MIL-PRF-83536/16A
AMENDMENT 5
10 July 1999
SUPERSEDING
AMENDMENT 4
13 May 1999

PERFORMANCE SPECIFICATION SHEET

RELAYS, ELECTROMAGNETIC, ESTABLISHED RELIABILITY, 4PDT,
LOW LEVEL TO 10 AMPERES, PERMANENT MAGNET DRIVE, HERMETICALLY SEALED,
ALL WELDED, TRANSIENT SUPPRESSED DC COIL

SOCKET PIN TERMINAL

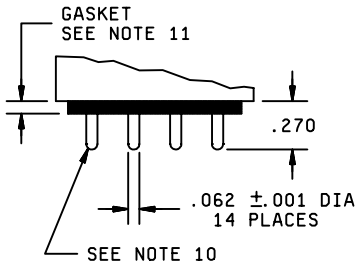
FIGURE 1, socket pin terminal diagram, delete and substitute:
